# Memorandum to the City of Markham Committee of Adjustment

October 30, 2023

**Files:** B/029/23, B/033/23, B/034/23, A/151/23, A/152/23, A/130/23, and A/131/23  
**Address:** 5077 14th Avenue, 52 Deib Crescent and 54 Deib Crescent, Markham  
**Applicant:** ZHX Development Group  
**Agent:** KBK Architects Inc.  
**Hearing Date:** Wednesday November 1, 2023

DRAWING  
FULL DEVELOPMENT  
SITE PLAN

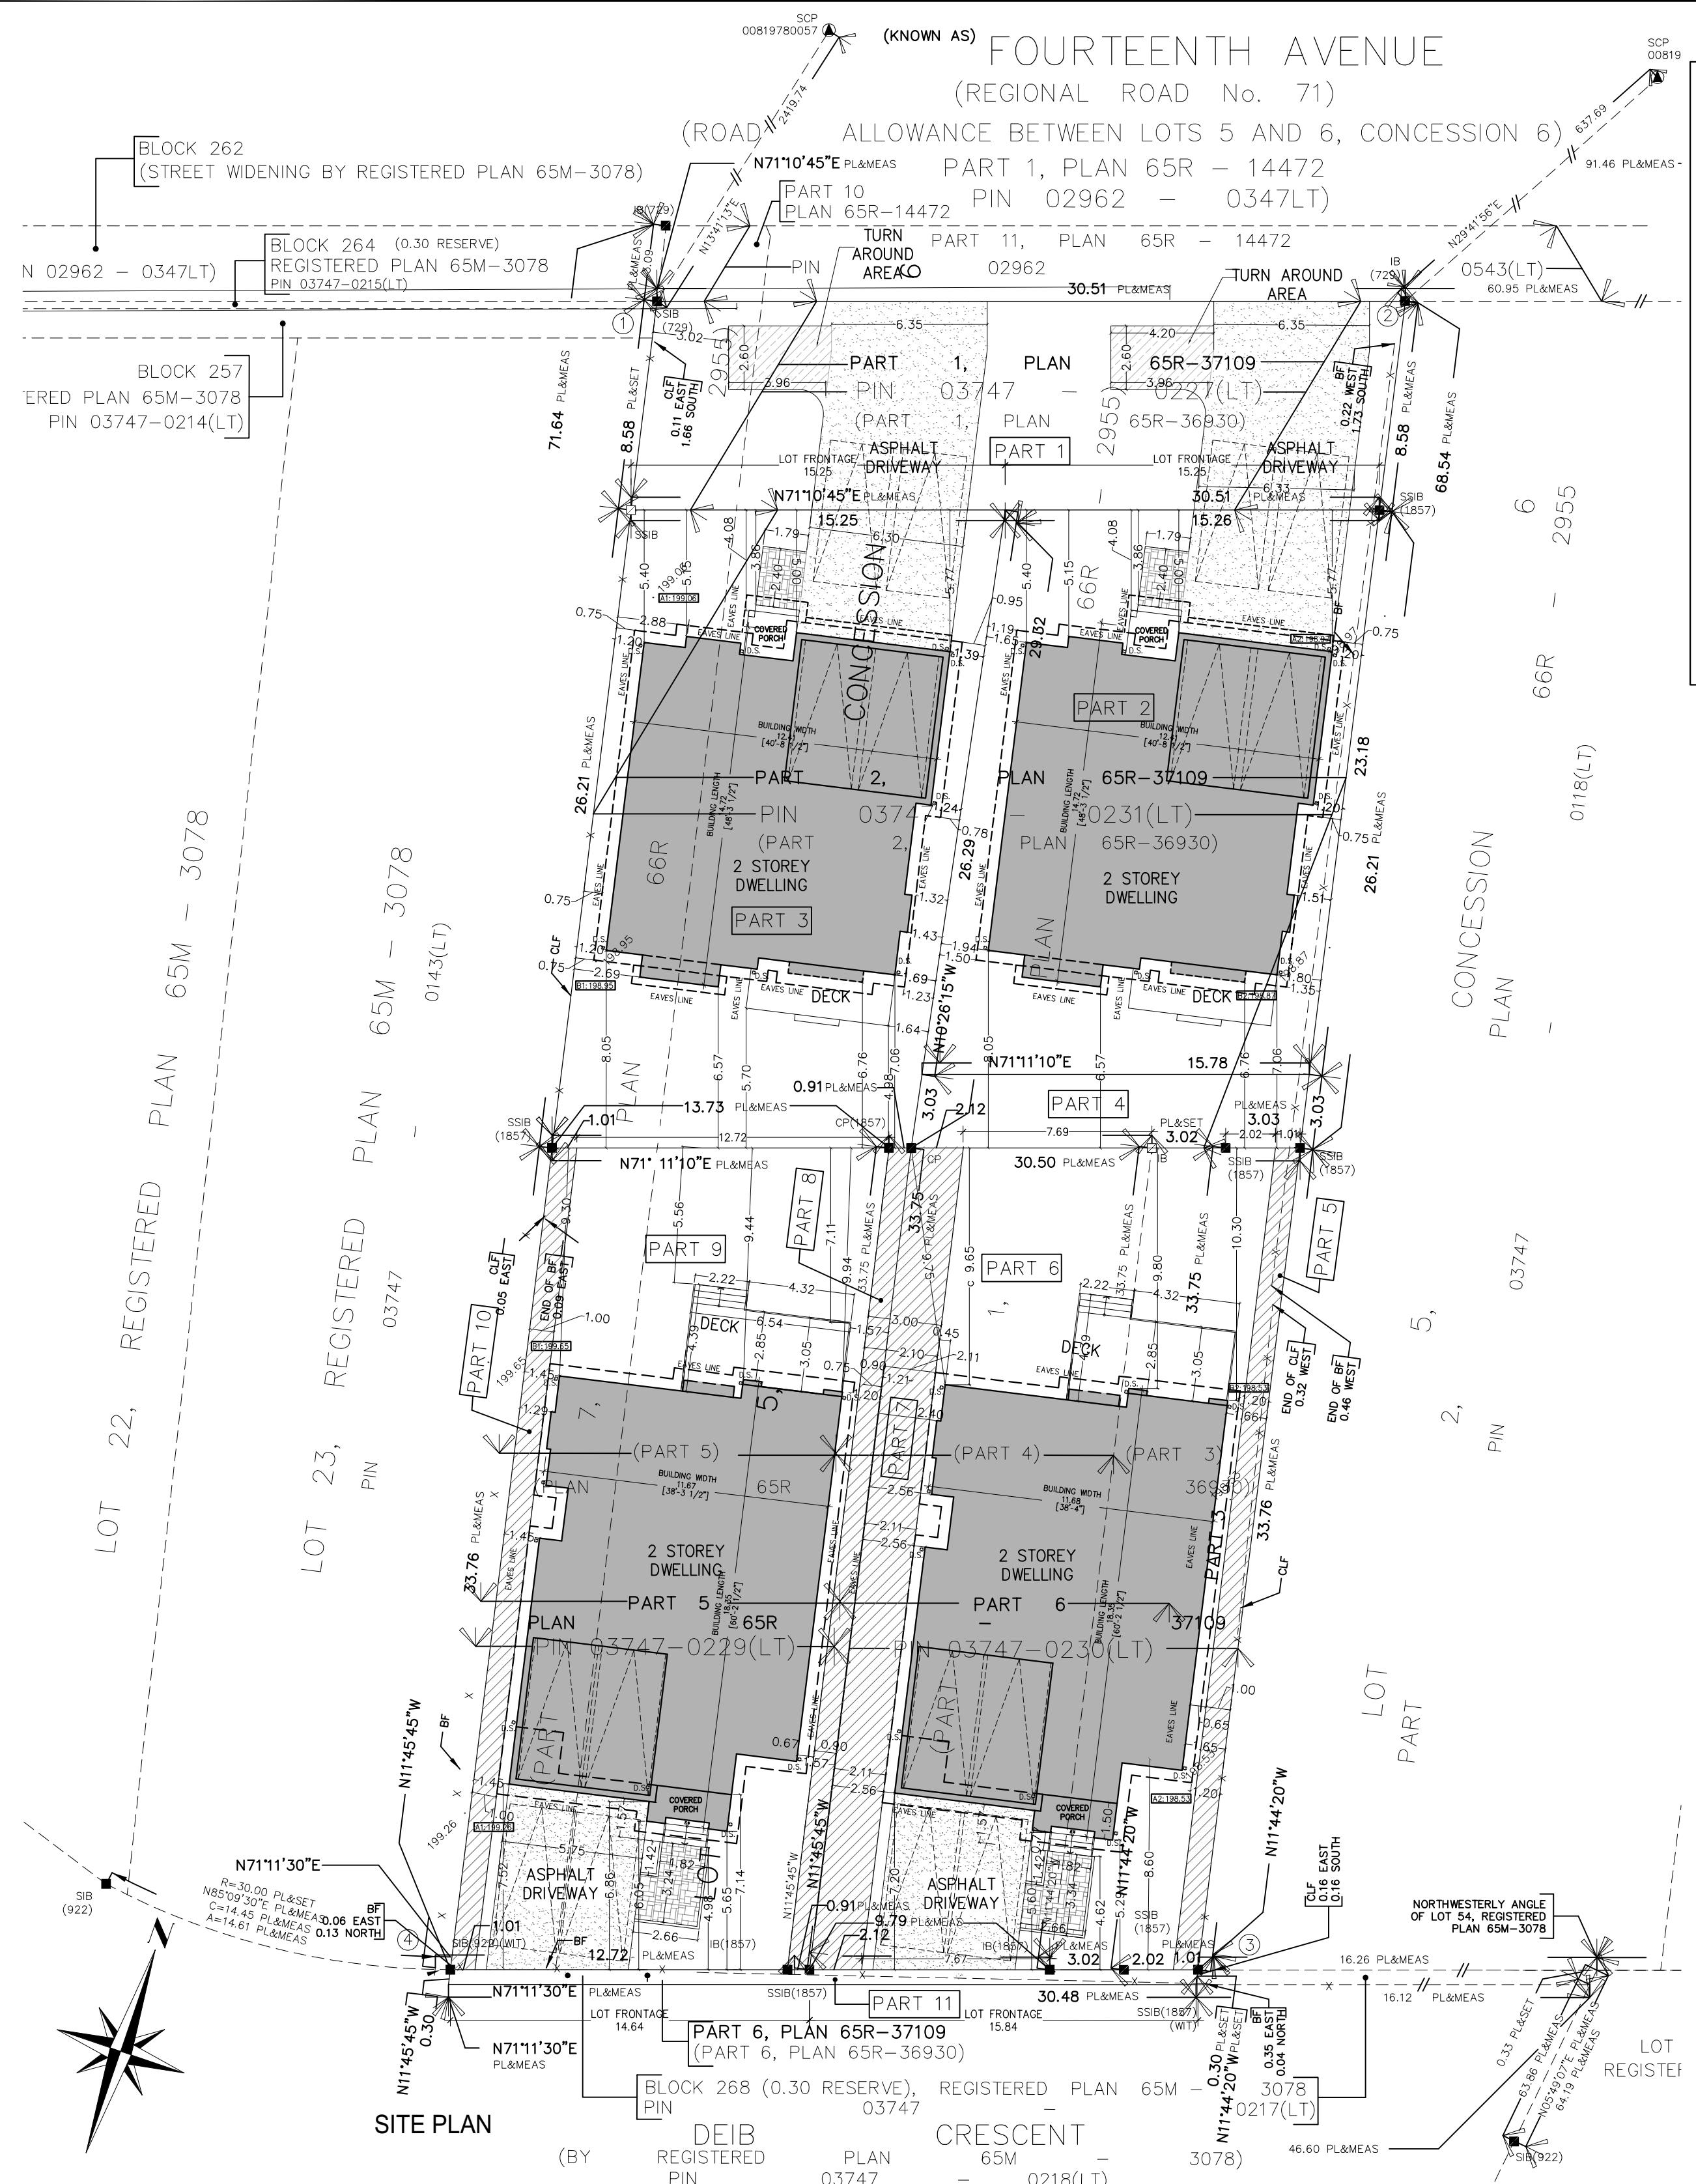
The Applicant has completed a Zoning Preliminary Review (ZPR) on August 4, 2023 to confirm the variances required for the proposed development. Staff note that the plans have since been revised to locate the hammerhead driveway turnaround space within the Region’s right-of-way, as per the Region’s comments. The Applicant has not submitted a revised ZPR, therefore Staff advise that it is the Applicant’s responsibility to ensure that the application has accurately identified all of the variances to the By-law required for the proposed development. If the variance request in this application contains errors, or if the need for additional variances is identified during the building permit review process, further variance application(s) may be required to address the non-compliance.

DRAWING  
 SITE SERVICING  
 COLOR-CODED DIAGRAM

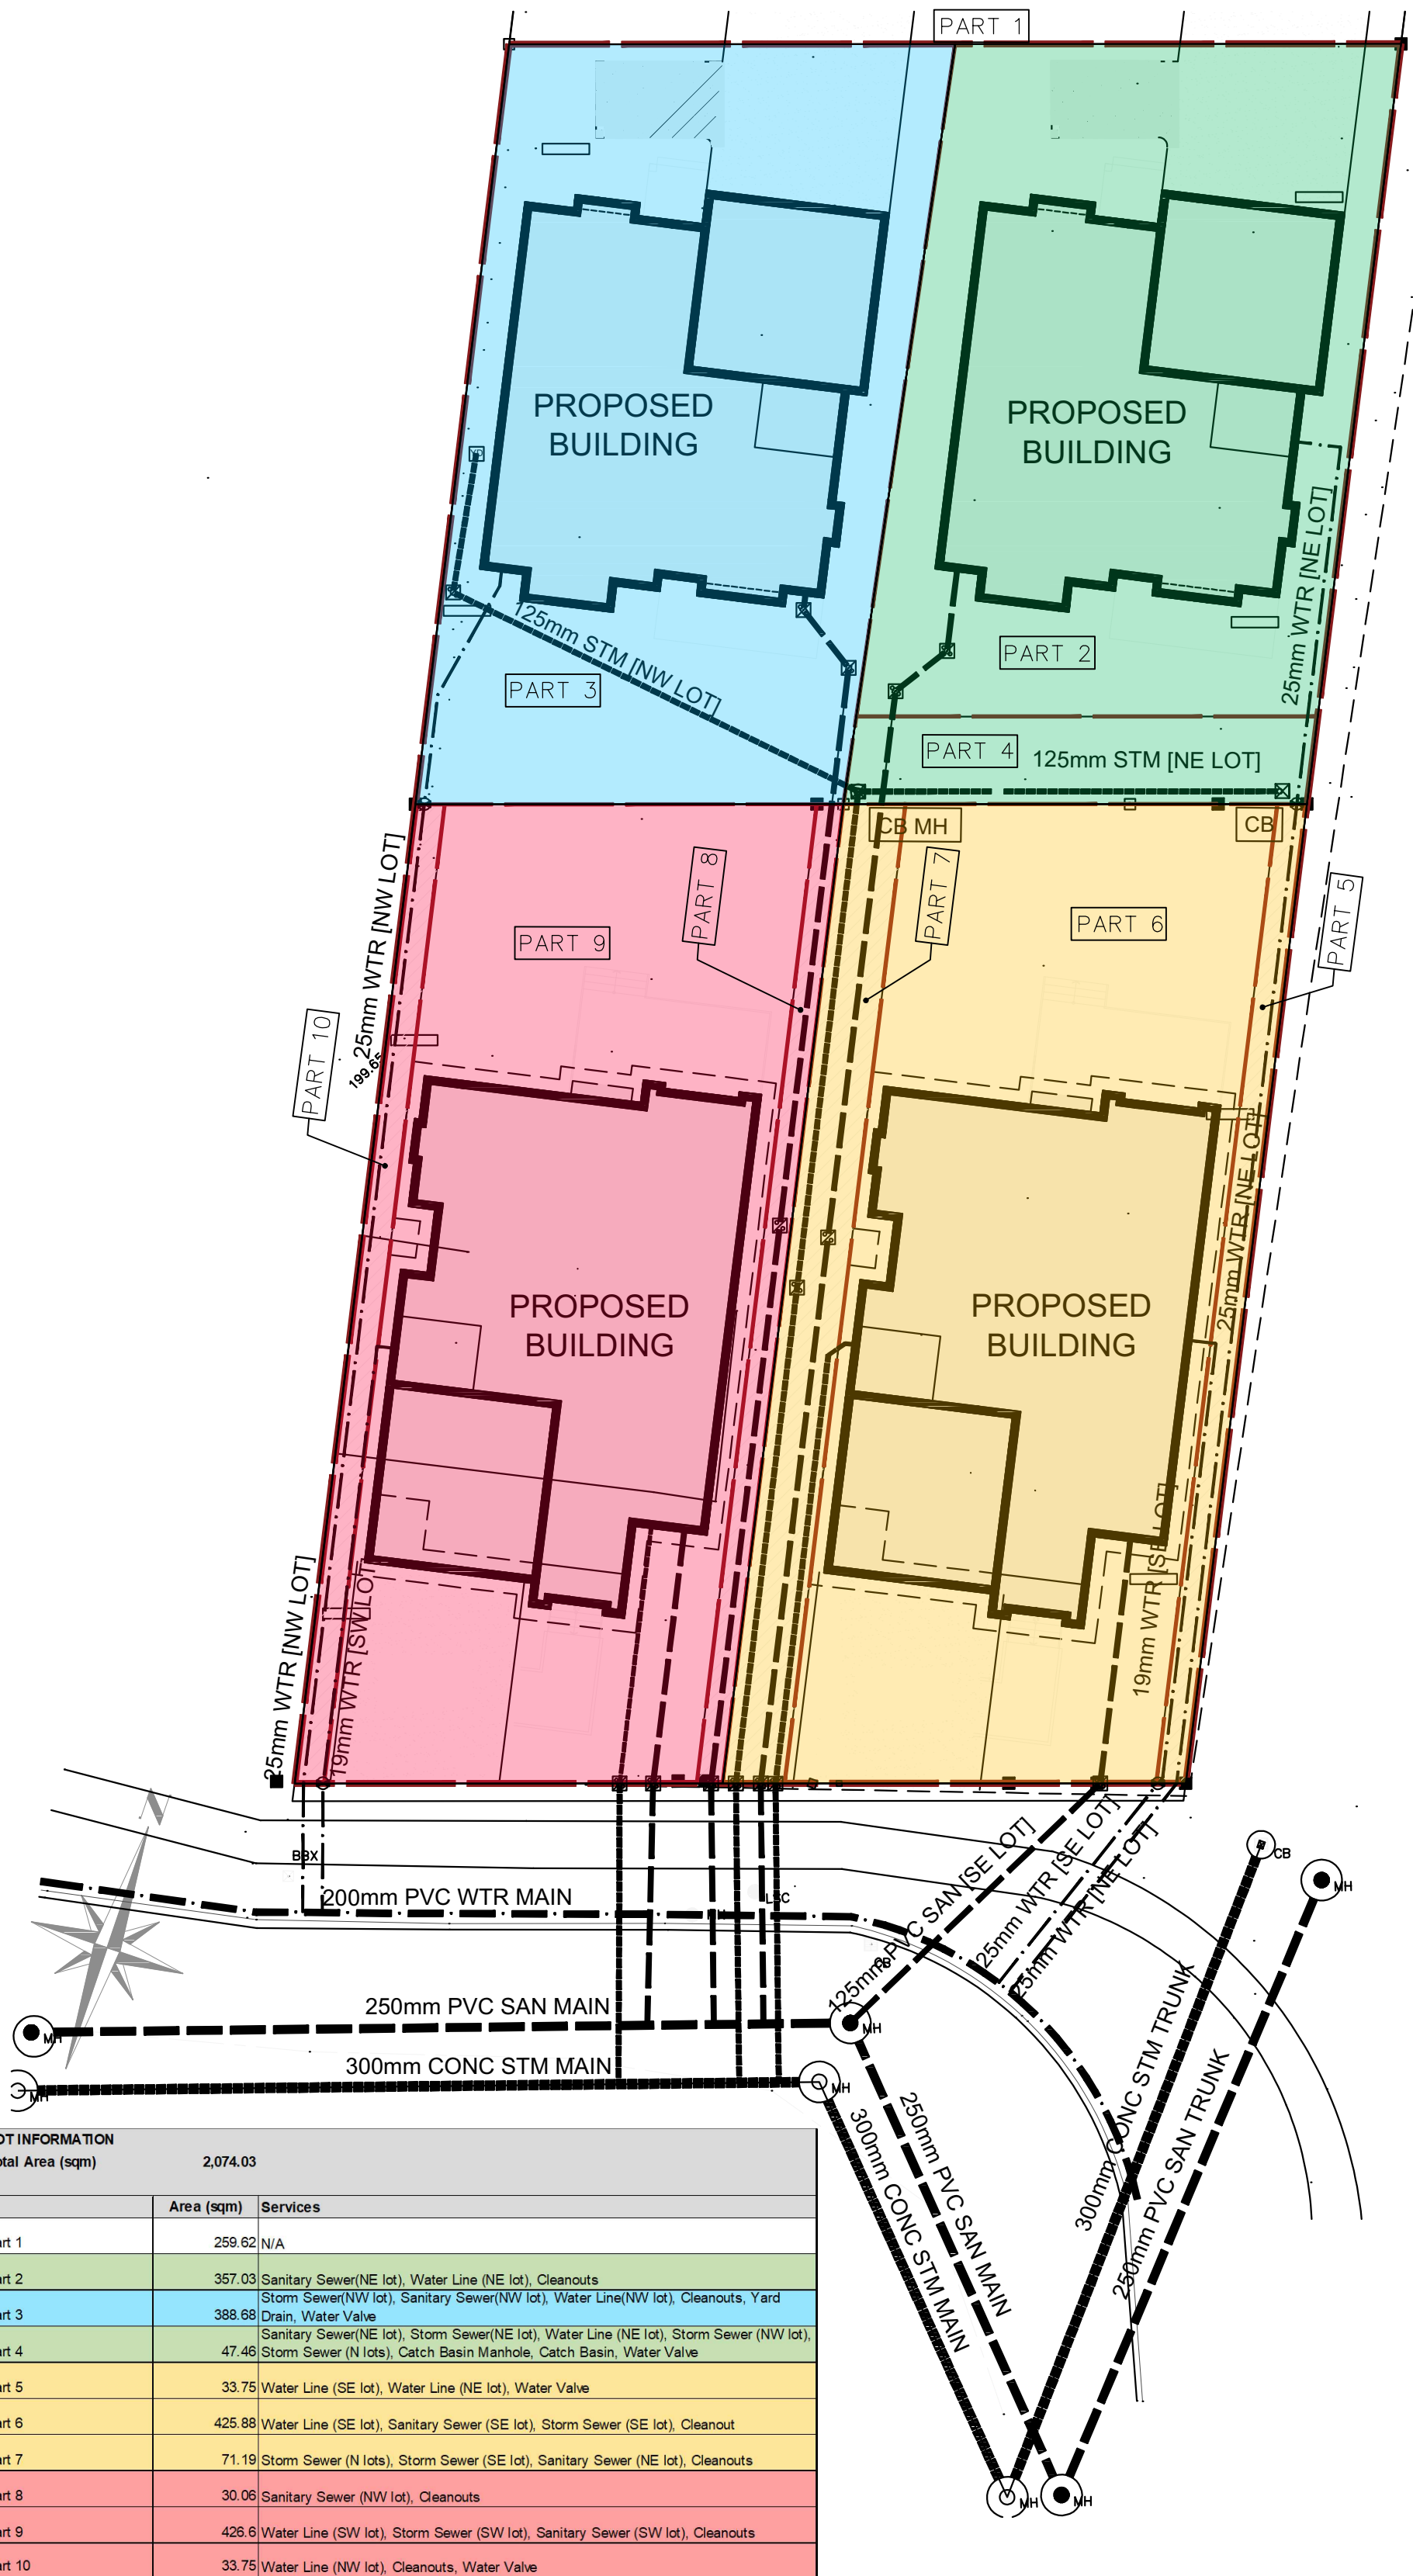
As servicing is unavailable from 14<sup>th</sup> Avenue, the Applicant is required to provide servicing connections from Deib Crescent via the establishment of servicing easements across 52 and 54 Deib Crescent (refer to Appendix “F” – Draft Servicing Plan). Additional details with respect to the servicing easements are provided in the comment section below.

As previously noted, servicing connection is unavailable from 14<sup>th</sup> Avenue. As such, the Applicant is required to provide servicing connections from Deib Crescent via the establishment of servicing easements across 52 and 54 Deib Crescent (refer to Appendix “F” – Draft Servicing Plan). Staff notes that in accordance with Section 7.1.5.4 of the Building Code, piping in any building shall be connected to the public services separately from piping of any other building. Therefore, the proposed dwellings on the retained and conveyed lots on 5077 14<sup>th</sup> Avenue must have separate water service and sanitary sewer lines, necessitating the need for separate servicing easements on 52 and 54 Deib Crescent in favour of the retained and conveyed lot, respectively. However, it is important to note that the proposed servicing arrangement has not been reviewed for compliance with the Ontario Building Code and that the appropriate approvals from the City’s Engineering Department and Building Standards Department will be required.

1. Provide zone of influence calculations and cross section drawings for all servicing easements illustrating the expected pipe inverts and foundation depths to determine easement widths for both construction and maintenance access. Please provide a minimum pipe separation of 0.5m outside of pipe to outside of pipe and a minimum 1 metre separation between the pipe and foundation walls.

8. That the Owner obtain necessary permits and/or make alternative servicing easement arrangements to show how individual water and sewer services will be provided for the retained and conveyed lots to the satisfaction of the Director of Engineering, Chief Building Official, and City's Solicitor or their designates; and,
